STATE OF CONNECTICUT
CONNECTICUT SITING COUNCIL

DOCKET NO. 488

APPLICANTS' RESPONSES TO INTERVENOR PLANNED DEVELOPMENT ALLIANCE OF NORTHWEST CONNECTICUT, INC. INTERROGATORIES

Existing 700 MHz LTE Coverage

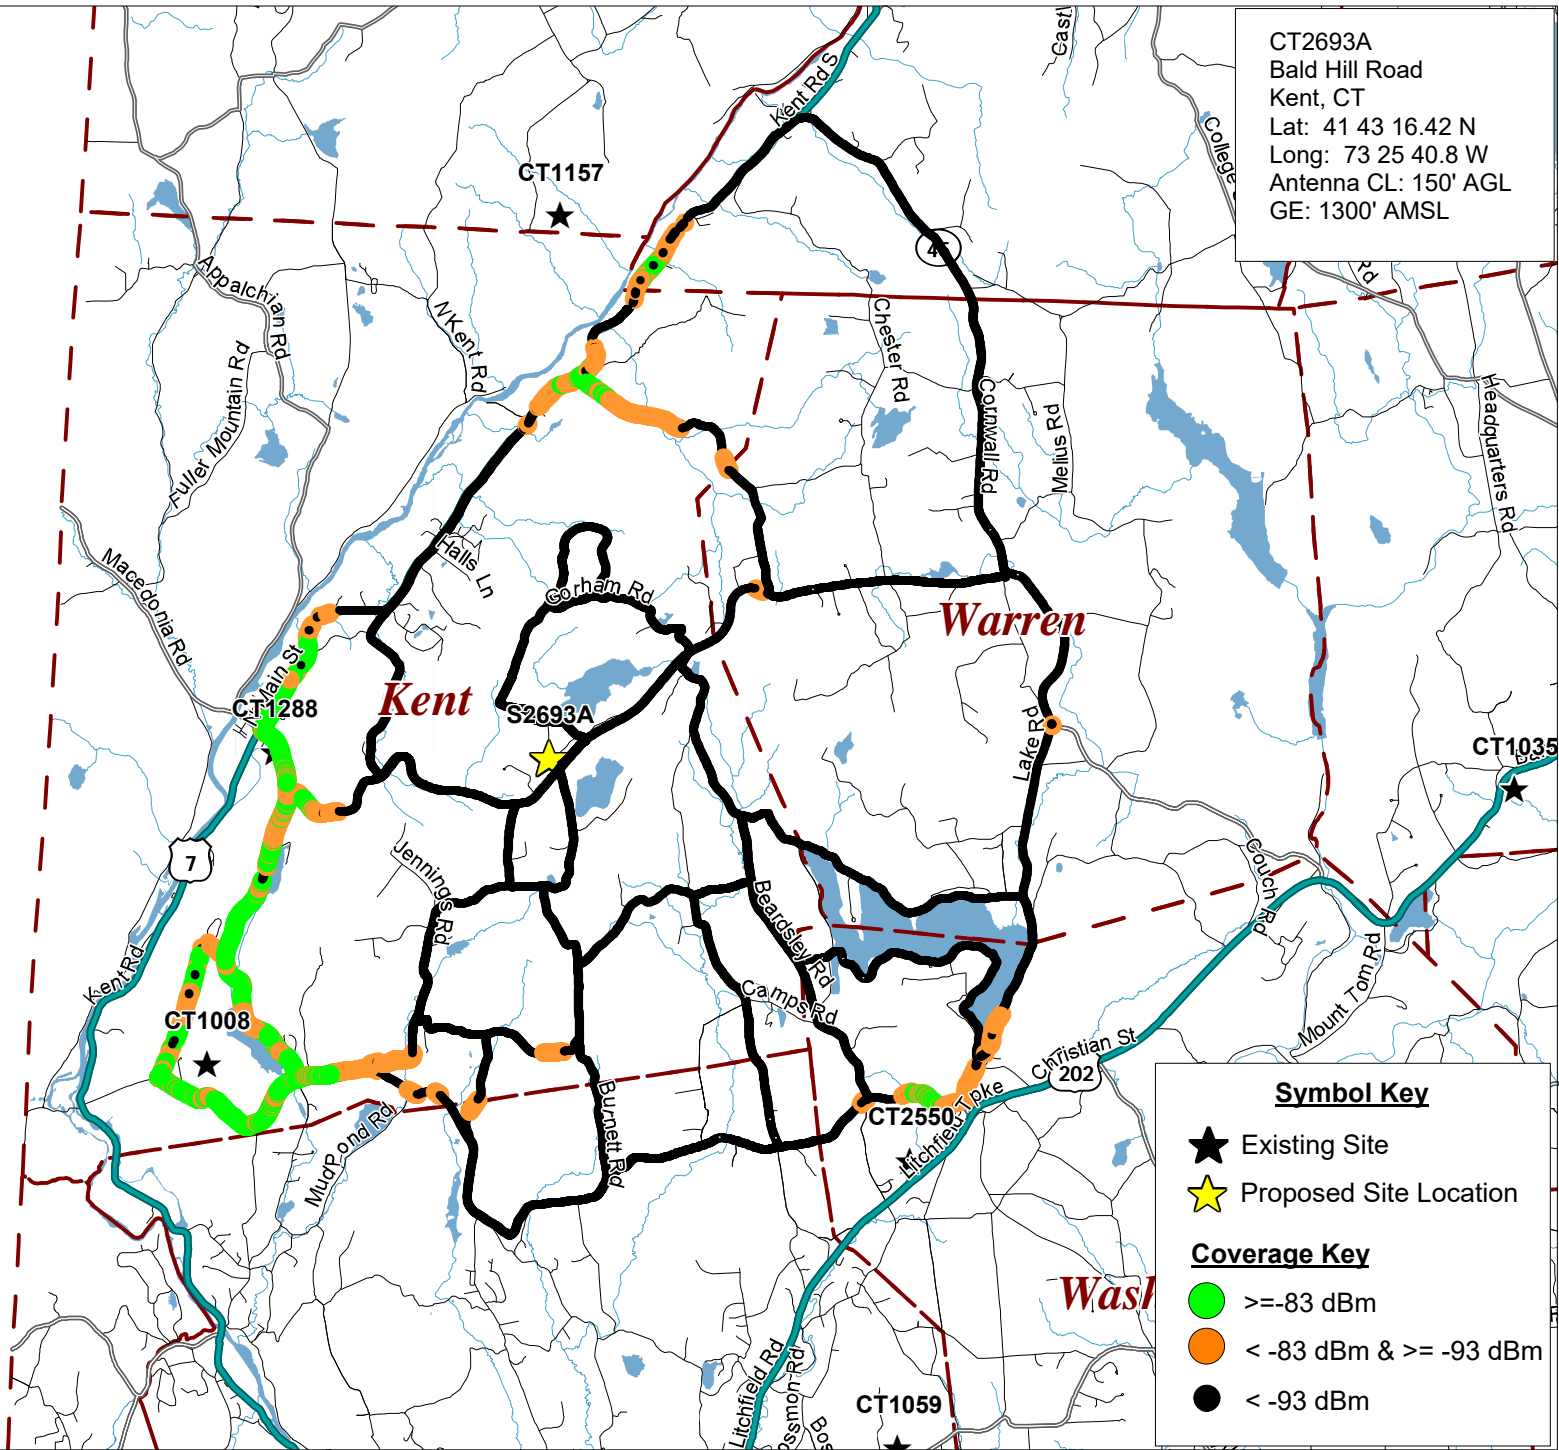
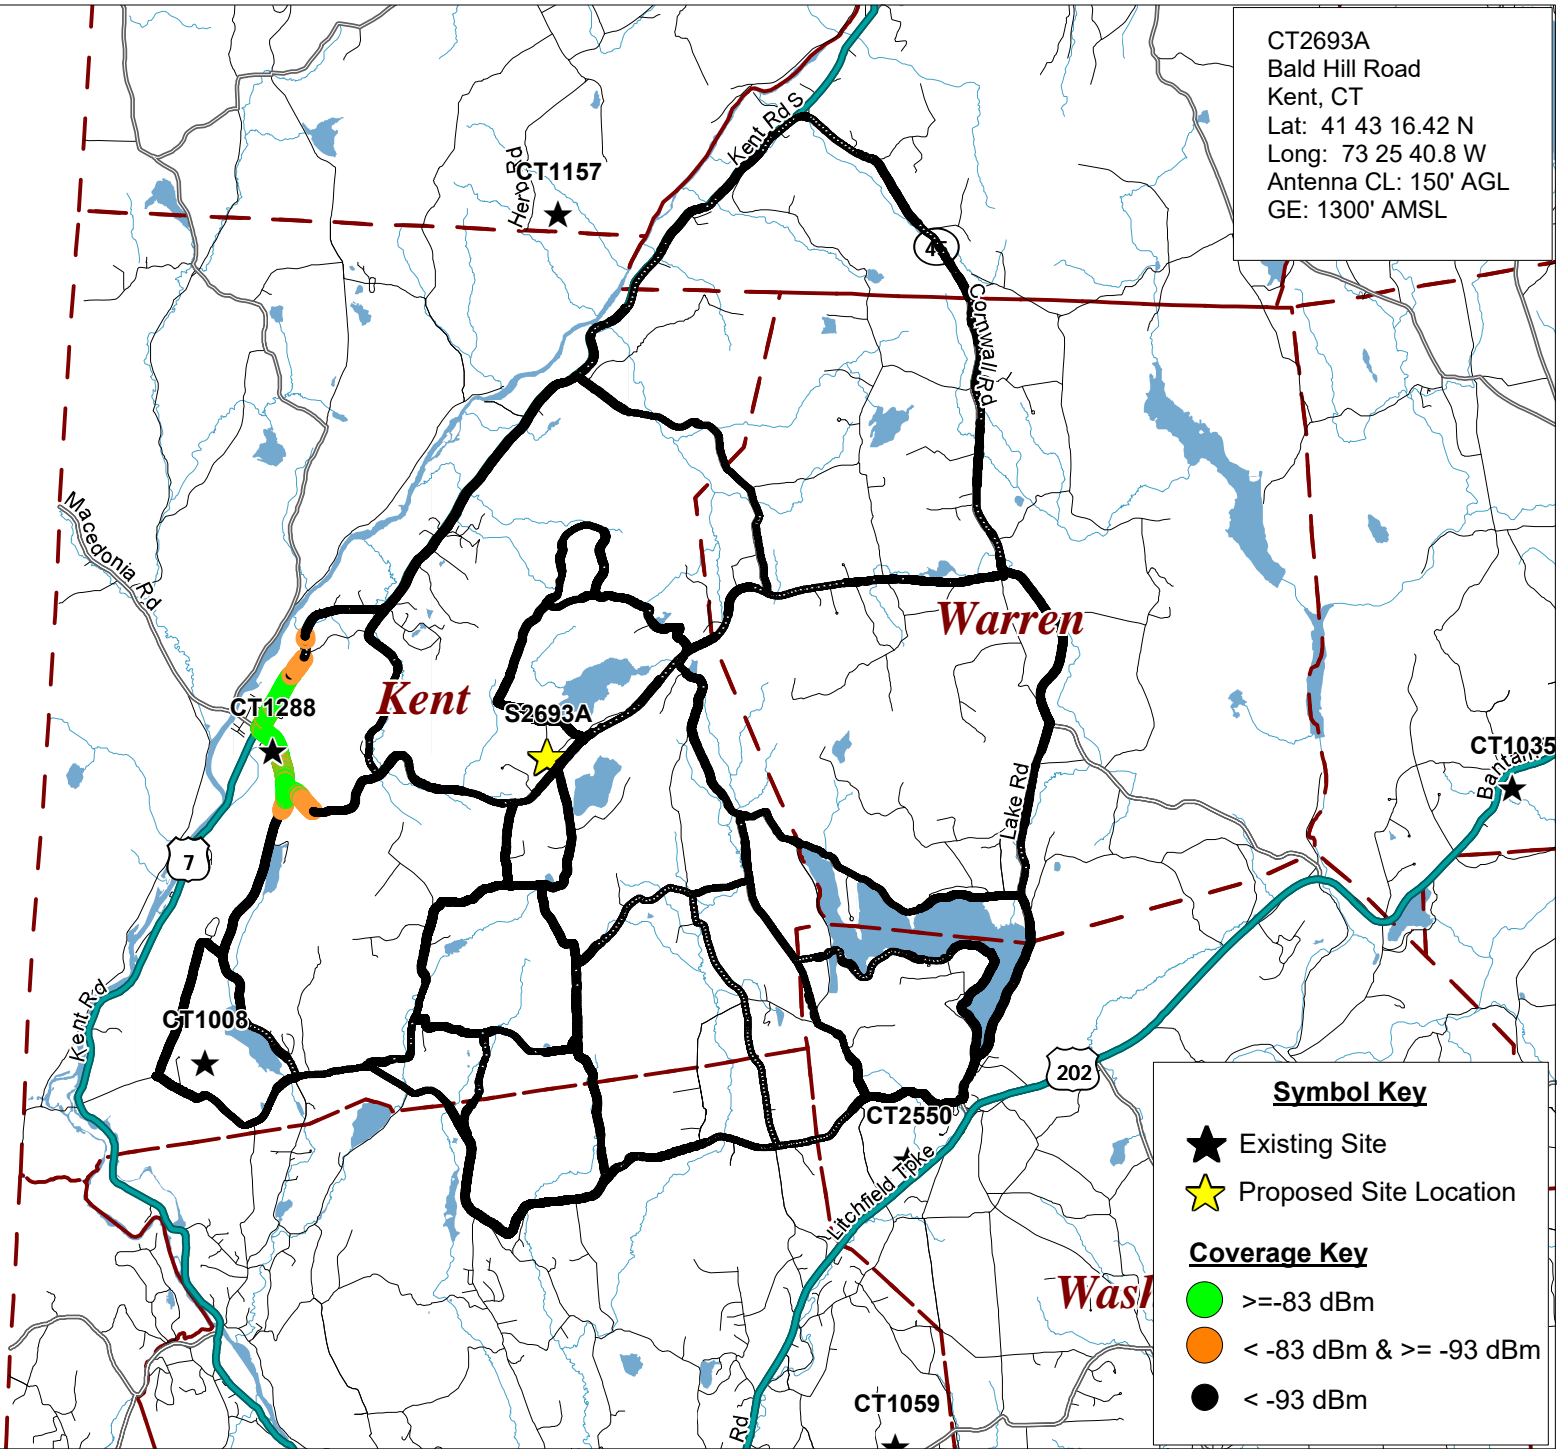
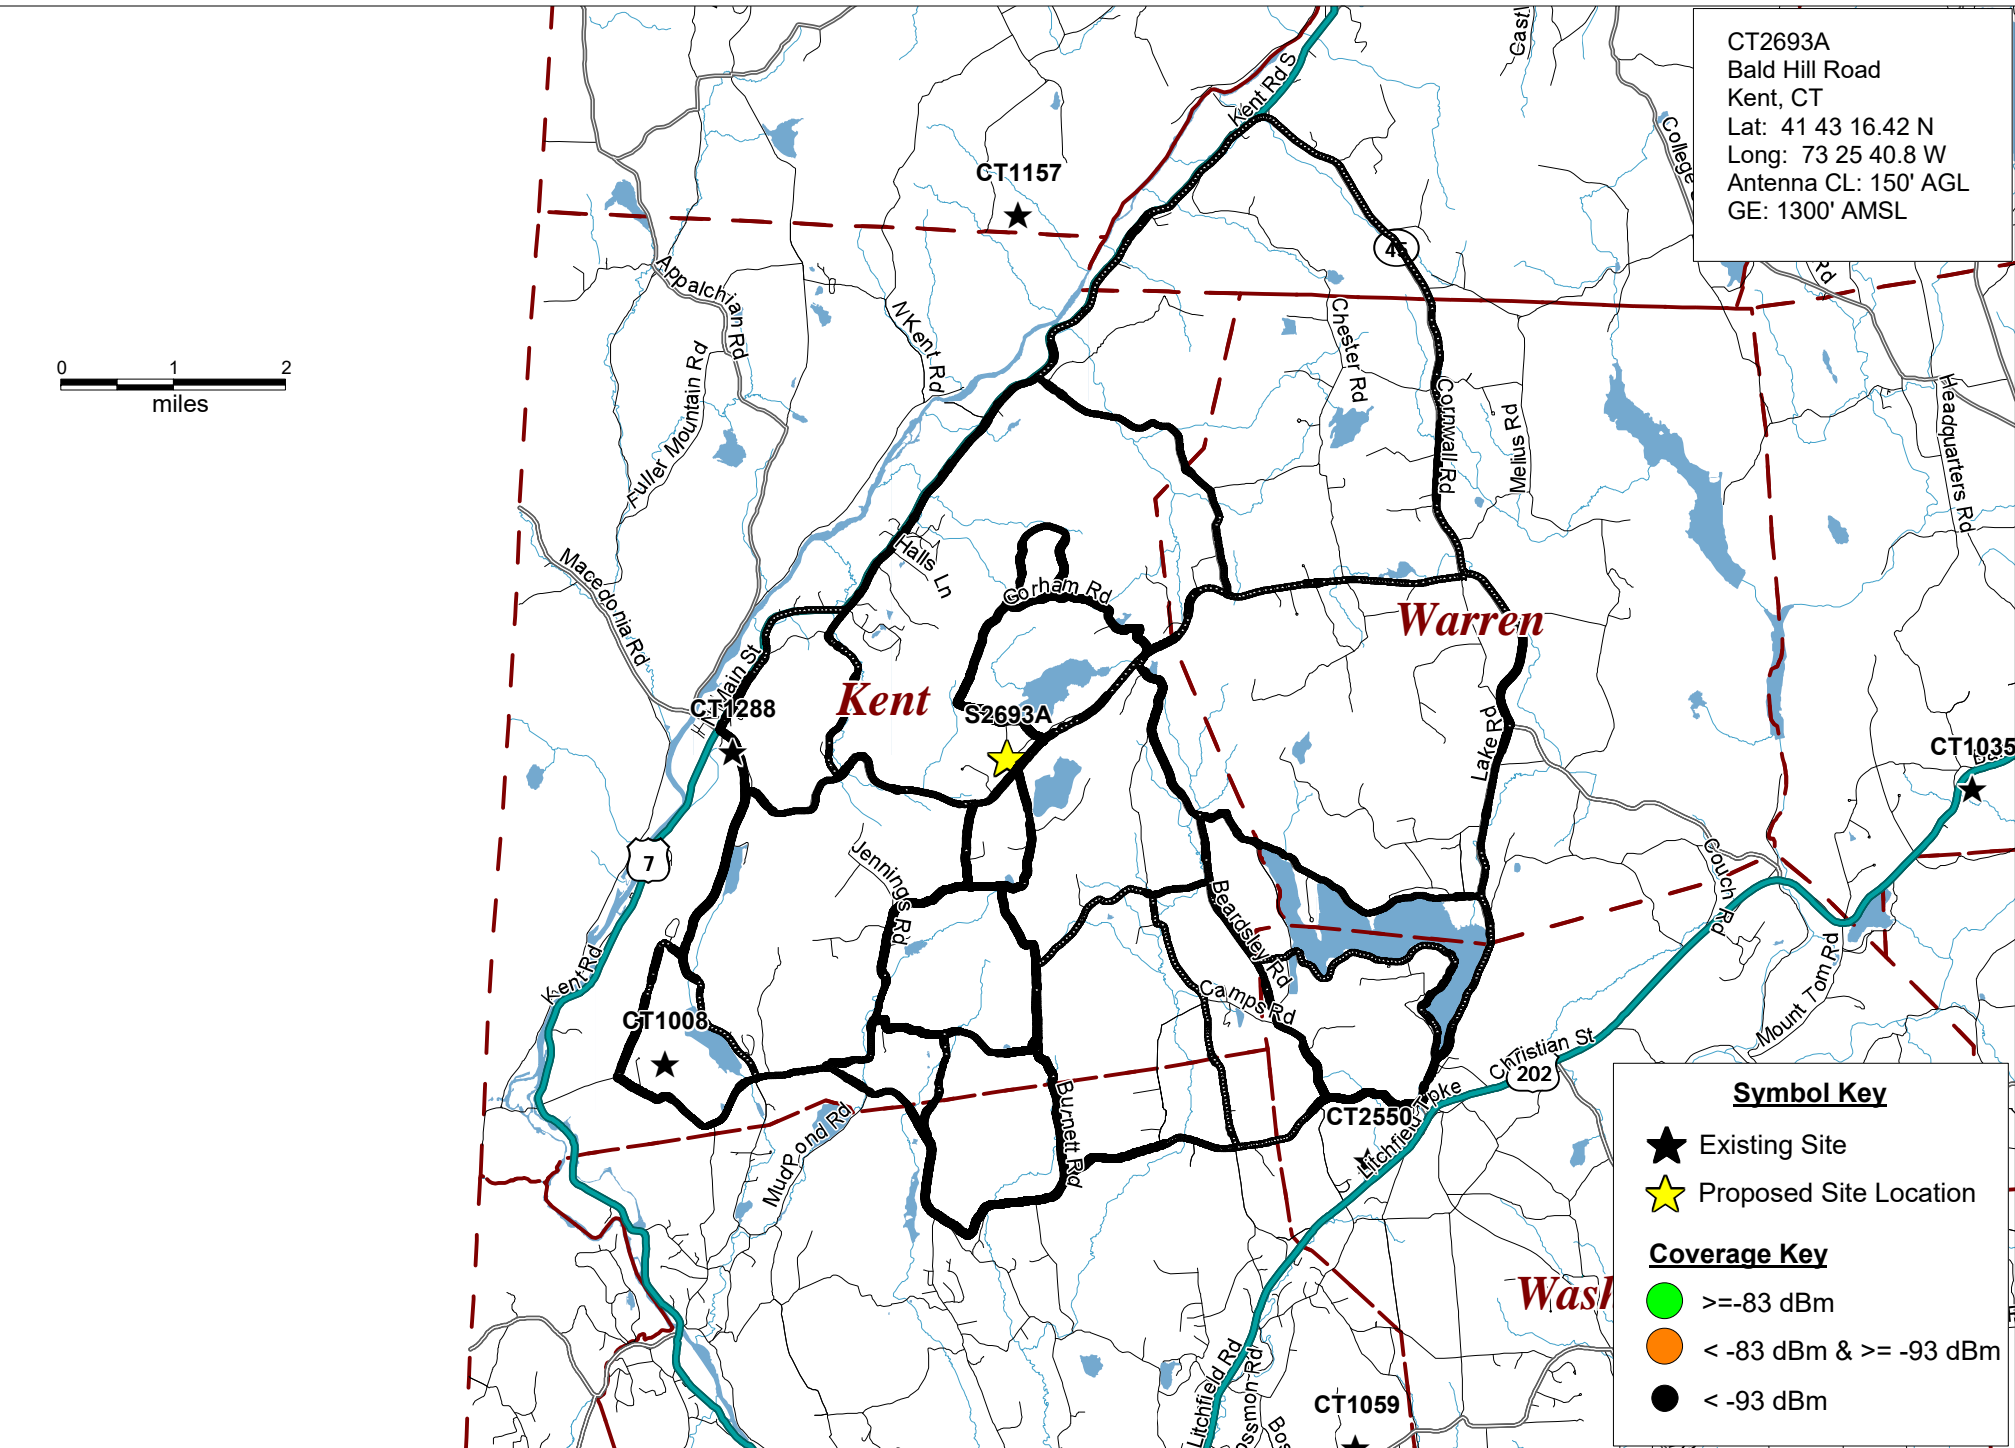
- A14. *See Response A8 and Application Section III.C.*
- Q15. Were drive tests (“scan tests”) that would verify the results of the calculated plots conducted? If so, please provide the data sets which were generated by the tests and note whether the data needs to be corrected for variables including, but not limited to, antenna position, gain and line loss.

- A15. *Drive test maps are enclosed in Attachment 4.*
- Q16. Has the applicant performed continuous wave (“CW”) tests from the proposed site or any other site either identified or considered?
